Groundwater Review Summary Form

Application # G- 18406

TO: Water Rights Section Date March 29, 2017
 FROM: Groundwater Section Aurora C Bouchier
Reviewer's Name
 SUBJECT: Application G- 18406 Supersedes review of na
Date of Review(s)

A. GENERAL INFORMATION: Applicant's Name: Springwater Red Angus Ranch LLC County: Jefferson

Water-Level Trends in Nearby Wells

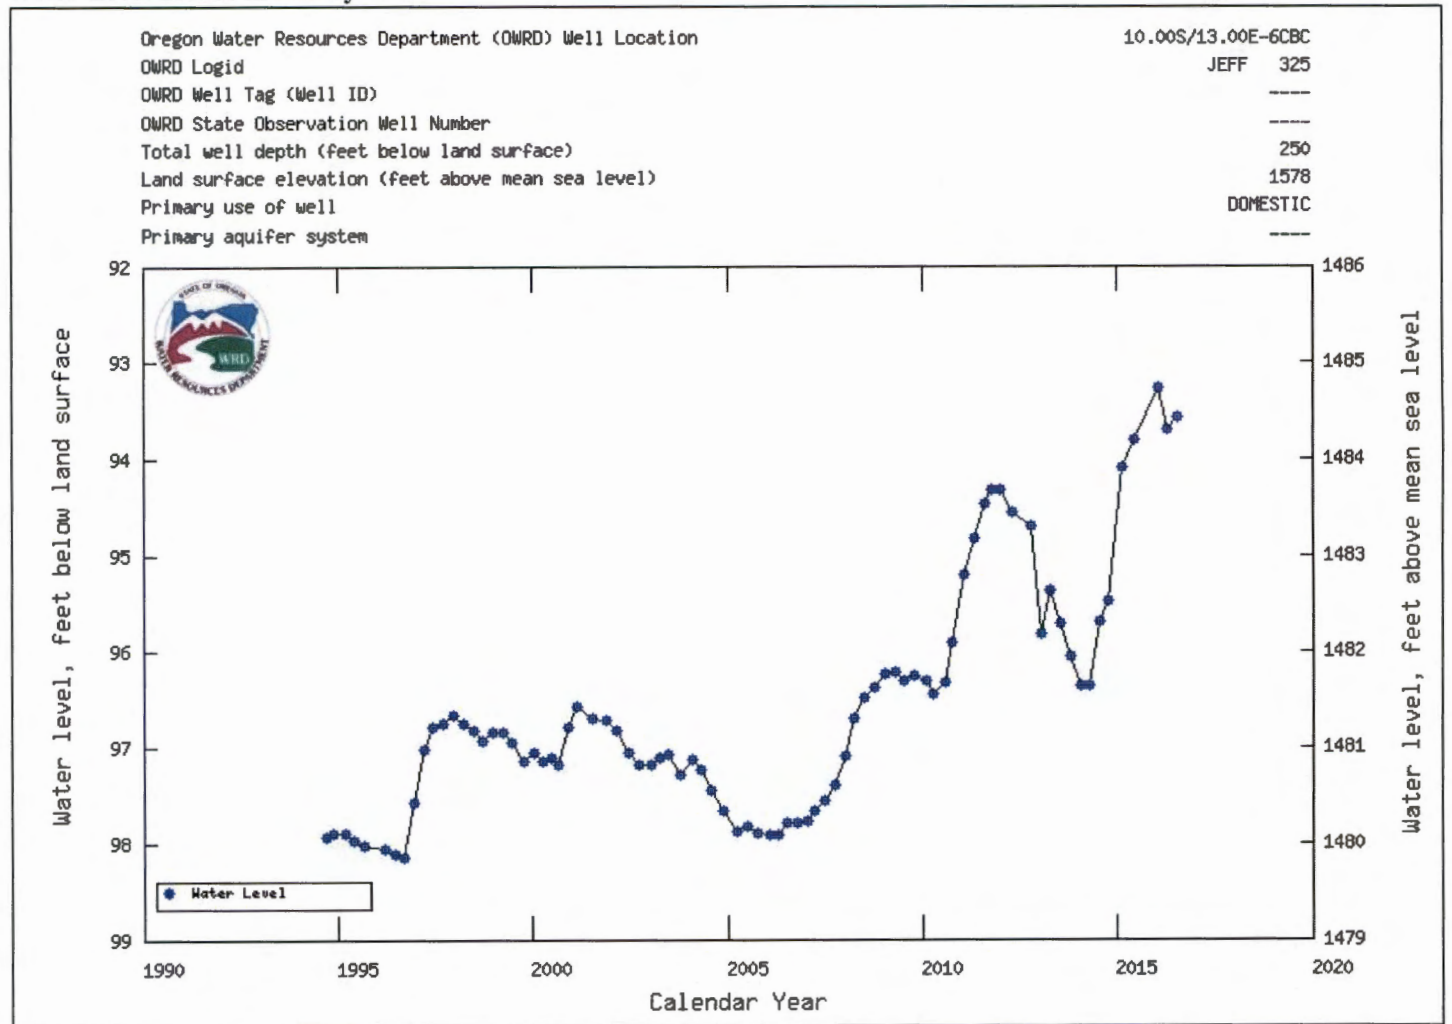
The nearest state observation well is JEFF 325, located approximately 0.6 miles to the northwest of the well. JEFF 325 has been monitored periodically since the mid 1990's through present. Overall, the water level in JEFF 325 has risen about 5 feet during the period of record. The hydrograph for JEFF 325 shows fluctuations which are likely driven by climatic factors, although long-term effects from the filling of Lake Billy Chinook / Lake Simtustus / Pelton Regulating Reservoir may be driving the overall increase in water level.
